PLANNING ADMINISTRATOR DECISION FOR MODIFICATION OF TENTATIVE SUBDIVISION PLAN

CASE NO.: SUB19-02MOD1
AMANDA NO.: 21-120096-LD
DATE OF DECISION: November 23, 2021
PROPERTY LOCATION: 575 Salem Heights Ave S, Salem OR 97302
APPLICANT: The Thomas Kay Co.

Summary: A modification to the Wren Heights subdivision, resulting in a change of access for Lot 1, in order to preserve trees along Salem Heights Road.

- A. Vicinity Map
- B. Subdivision Plan and proposed modified to Lot 1 driveway
- C. Applicant's Written Statement

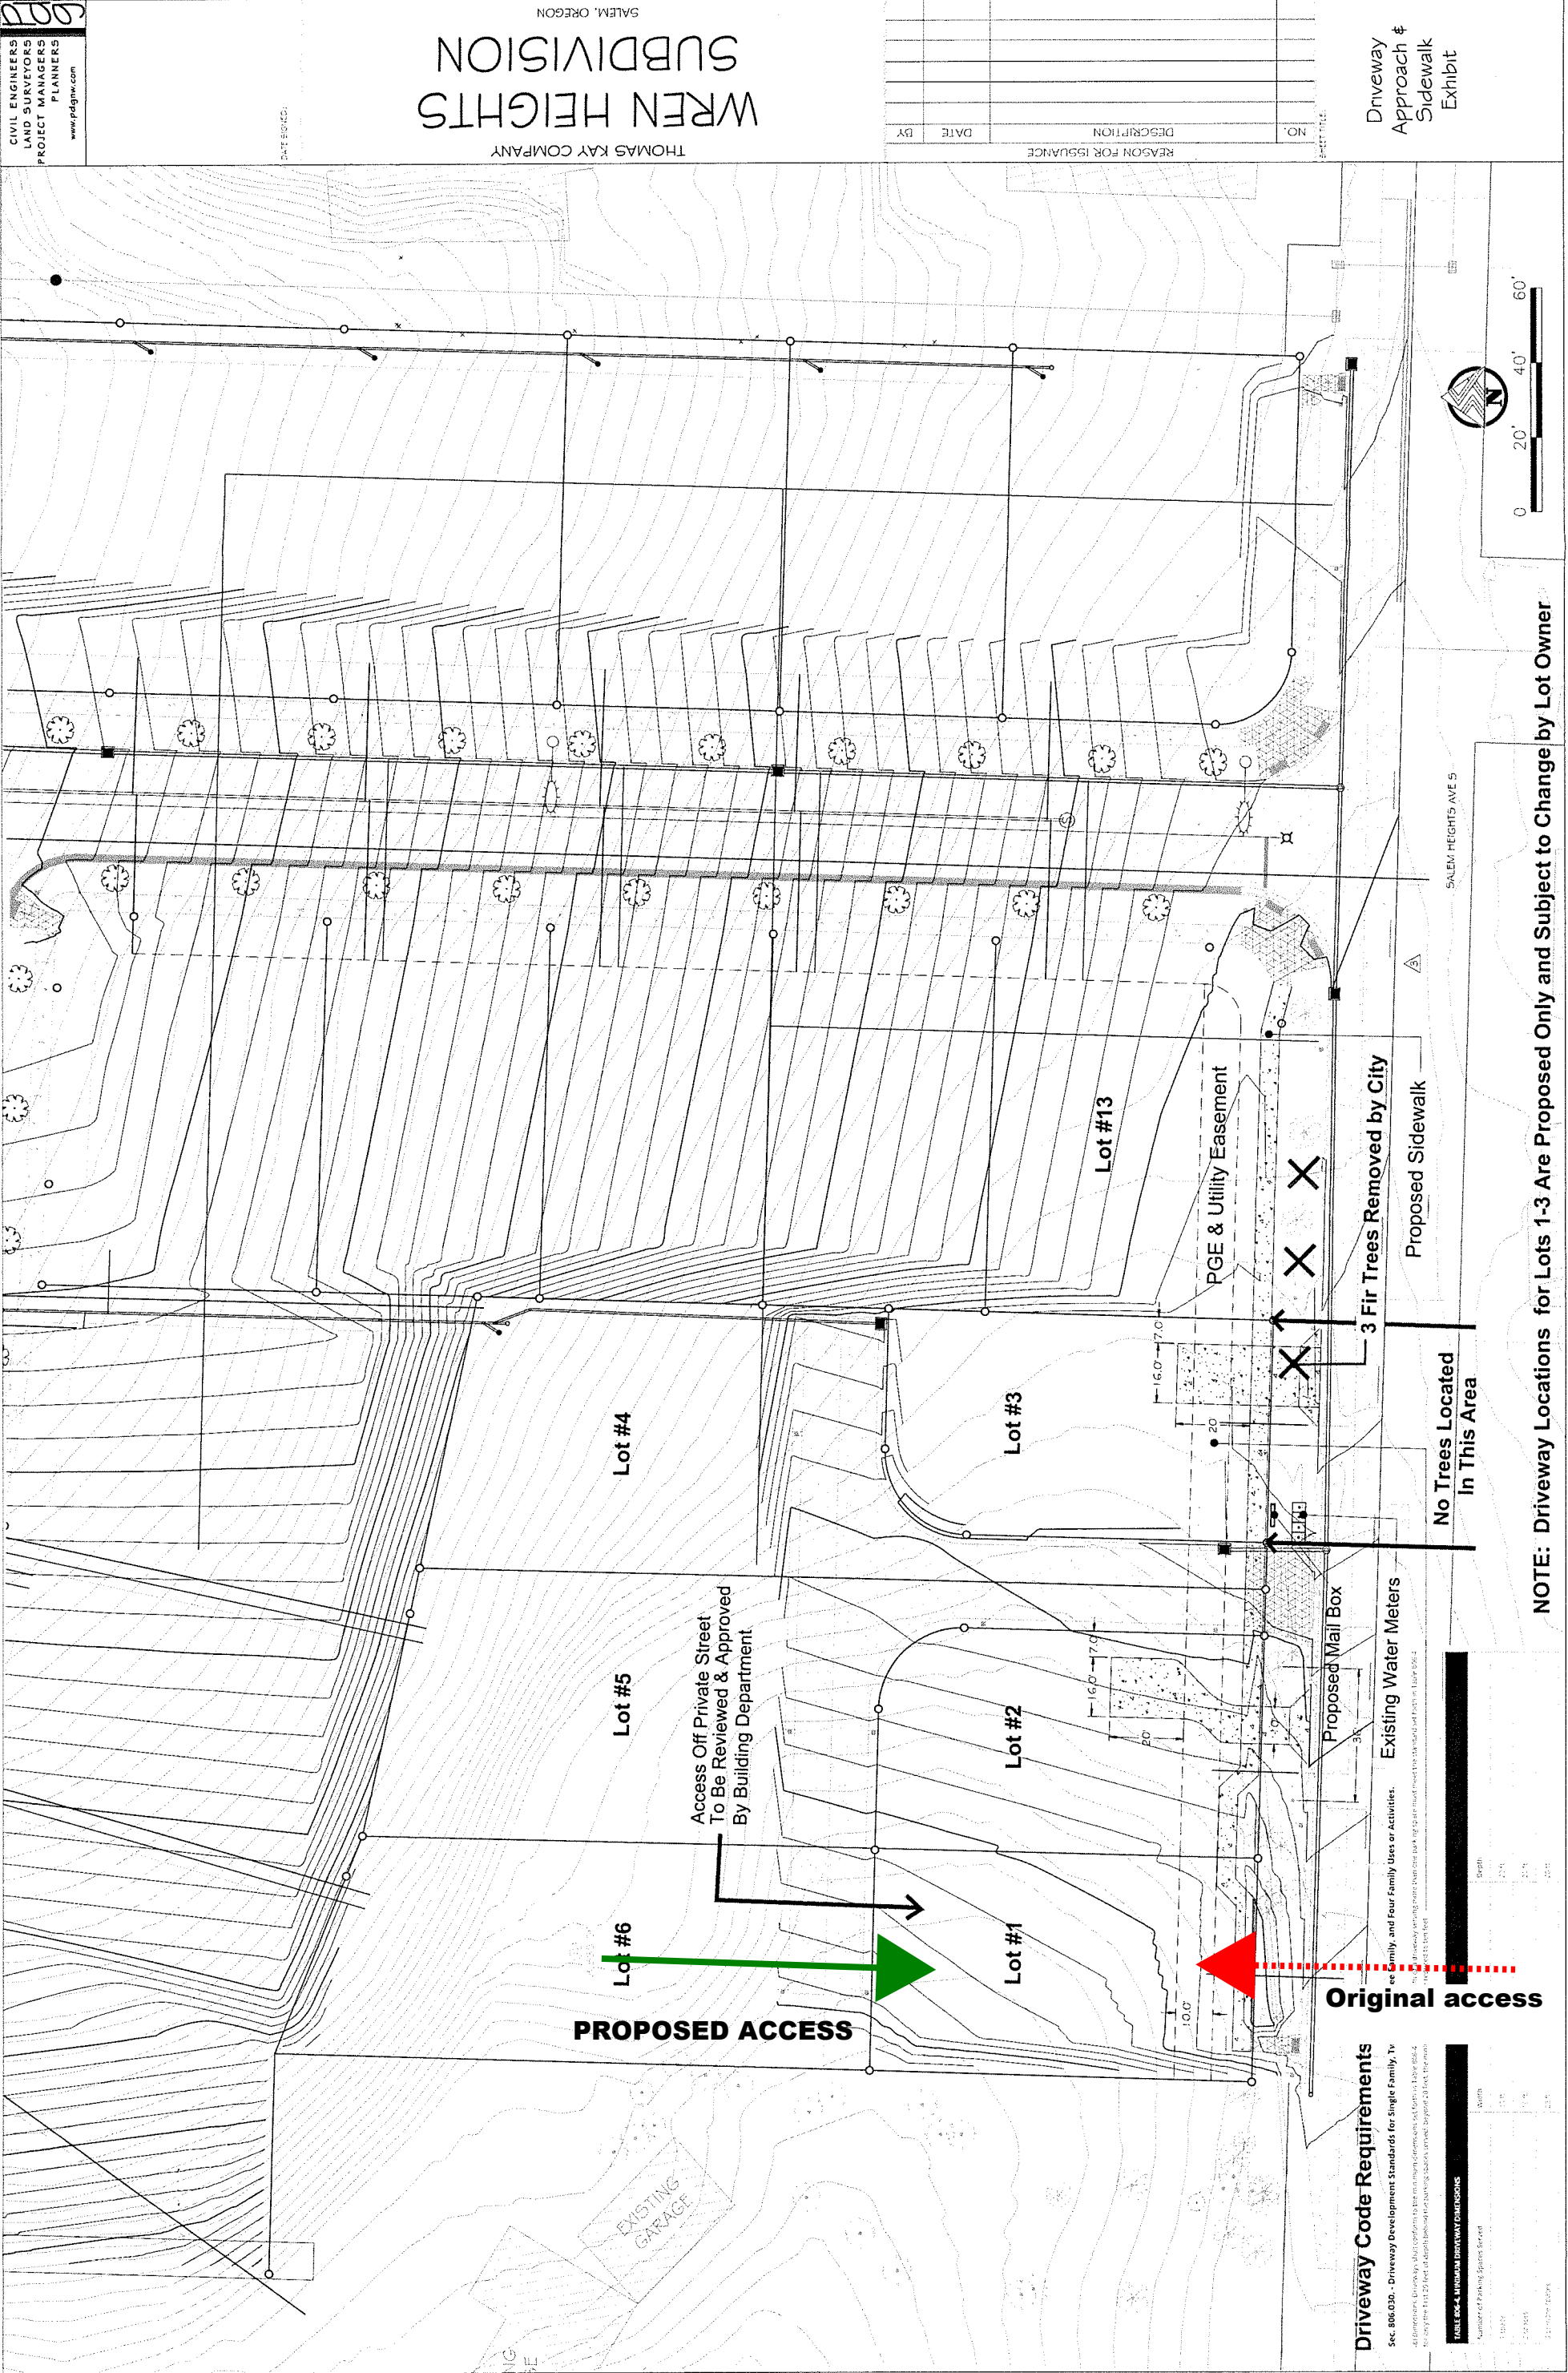
The applicant's proposed modified tentative subdivision plan of Lot 1 is included in **Attachment B** and written statement addressing the approval criteria is included as **Attachment C**.

Finding: The proposed modification is consistent with the conditions of the original approval. The modification proposes minor changes to the access of proposed Lot 1, which move access from Salem Heights Avenue to an internal flag lot accessway along the rear of Lot 1. The minor change is necessary to preservation of four trees abutting Salem Heights Avenue. The need to modify Condition 3 is only to relocate the access for Lot 1, which was originally proposed to take direct access to Salem Heights Avenue. Direct access would be in direct conflict with the abutting trees and preservation of the abutting trees is conditioned in the decision. The access for Lot 1, as proposed by the modification, is to use the accessway along the rear of Lot 1. The original accessway was proposed to serve Lots 4-6, but since Lots 1-3 also abutted the accessway a condition was imposed to ensure the accessway remained in conformance with SRC 800.025, which only allows four lots to be served.

Condition 3 is proposed to be modified to allow Lot 1 to access the flag-lot accessway in order to alleviate the conflict with the four existing trees abutting Lot 1 and Salem Heights Avenue.

- Condition 3:** Proposed Lots ~~4~~ **2 and 3** shall not have access to the flag lot accessway serving Lots 1 and 4-6.
- Condition 4:** Design and construct stormwater facilities pursuant to SRC Chapter 71 and Public Works Design Standards.
